# HISTORIC AND DESIGN REVIEW COMMISSION

August 18, 2021

**HDRC CASE NO:** 2021-367  
**ADDRESS:** 1129 N HACKBERRY ST  
1127 N HACKBERRY ST  
1123 N HACKBERRY ST  
**LEGAL DESCRIPTION:** NCB 513 BLK LOT 3 & 4  
**ZONING:** C-2, H  
**CITY COUNCIL DIST.:** 2  
**DISTRICT:** Dignowity Hill Historic District  
**APPLICANT:** Mary Hardee/HARDEE MARY ELLEN &  
**OWNER:** HARDEE MARY ELLEN &  
**TYPE OF WORK:** Fencing  
**APPLICATION RECEIVED:** July 21, 2021  
**60-DAY REVIEW:** Not applicable due to City Council Emergency Orders  
**CASE MANAGER:** Edward Hall  
**REQUEST:**

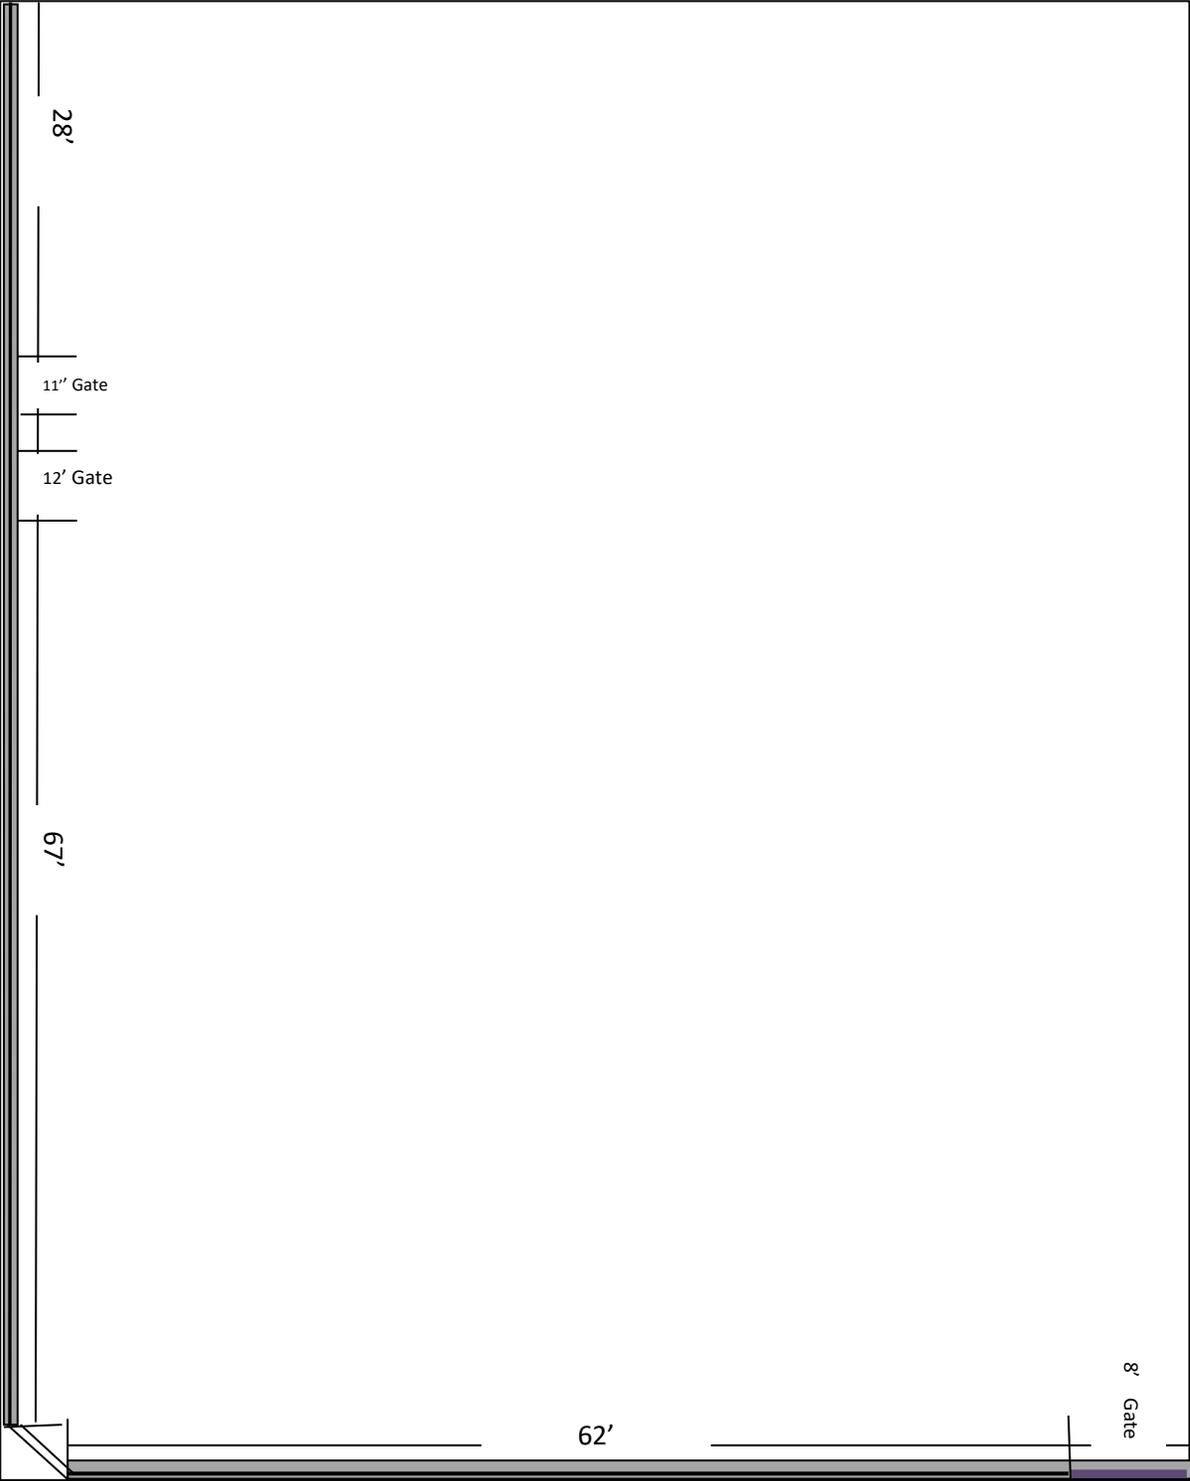
Fence directly across the street.

312 Sherman St

with Tap Measure.

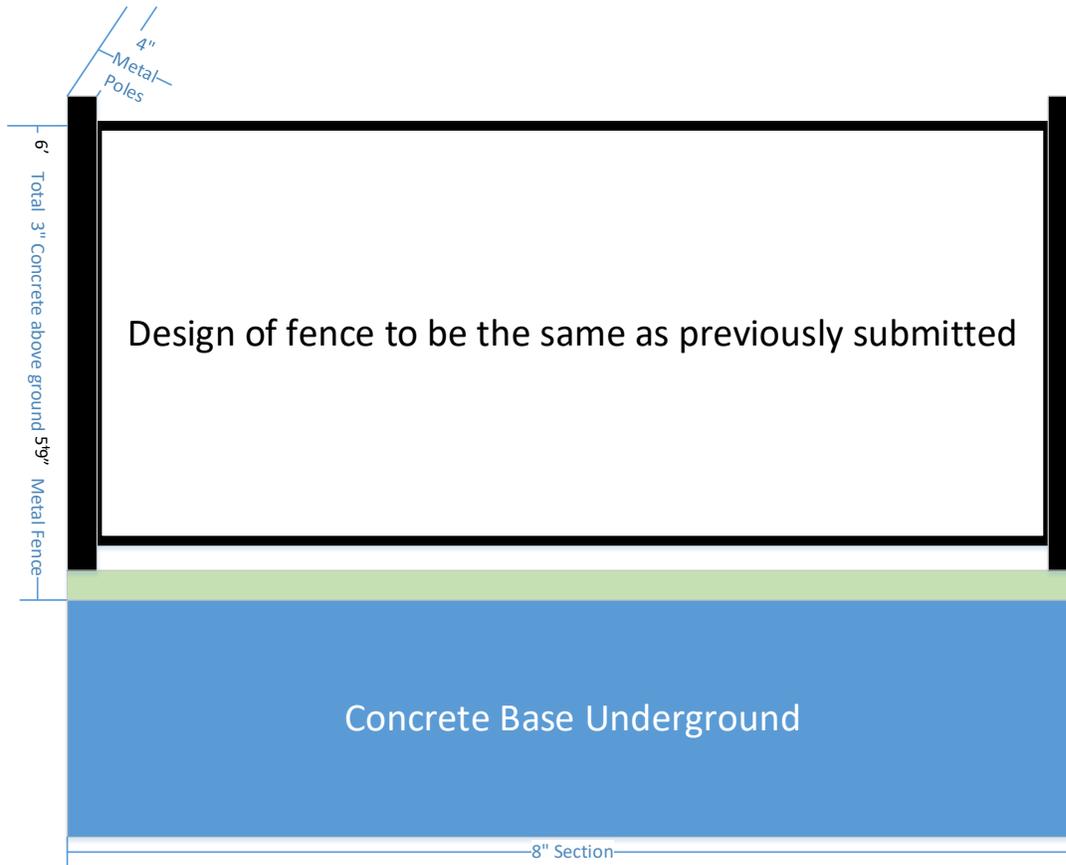
The fence will look like the following to match the existing already approved fence:

The fence will be 8" wide of cement base with the fence 2" in width.

This is what the fence will look like when finished from above:

- i. That the overall height of the proposed fencing not exceed four (4) feet in height, as noted in finding b.
